BRIDGE No 23 — CONCRETE ALTERNATE

RAMP P OVER RAMP V/Y RAMP M & I-85

END BENTS 1 & 6

PROJECT NUMBER PEAC I-85-1(201)

1 S-12 SECTION
3/8" = 1'-0"

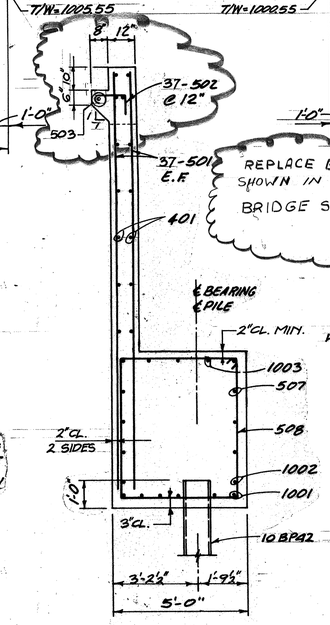
REPLACE BACKWALL AS SHOWN IN DETAIL "B". SEE BRIDGE SHEET 1 OF 9.

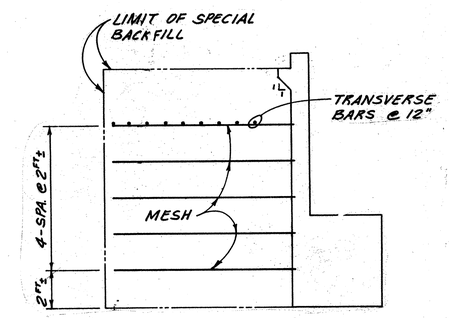
△ NOTE:
1 MESH SHOWN HERE IS FOR GEORGIA STABILIZED EMBANKMENT
2 PLACING AND DETAIL DRAWINGS SEE WALL PLANS.
